3.2TL Front Suspension Clunks

ACURA ServiceNews

ETM Fix: Keyless Receiver Location

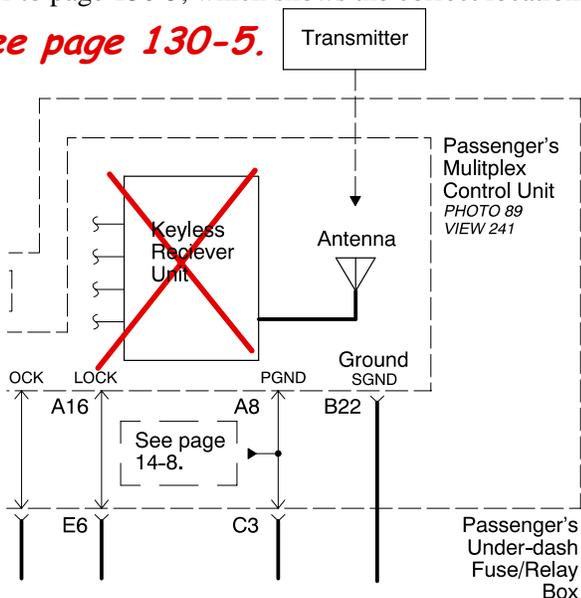
The circuit diagram on page 130-1 of the '01 3.2CL ETM shows an incorrect the location for the keyless receiver unit. Make a note on that page to refer to page 130-5, which shows the correct location.

See page 130-5.

S/M Fix: OPDS Unit Location

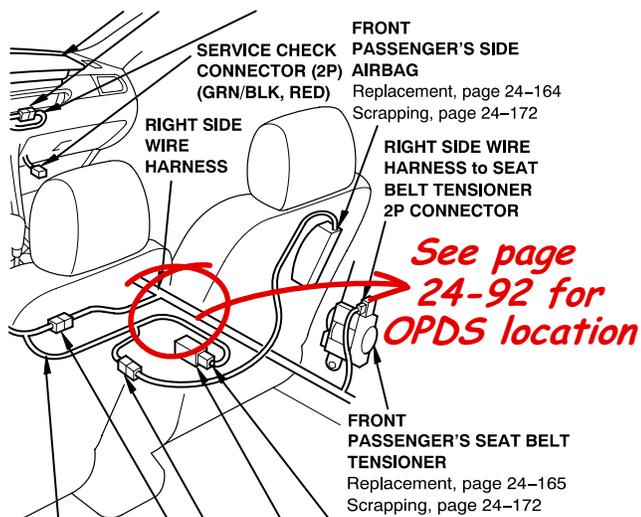
In the '96-00 3.5RL S/M, the component location index on page 24-15 doesn't show the occupant position detection sensor (OPDS) control unit in the front passenger's seat. Make a note on that page to refer to page 24-92.
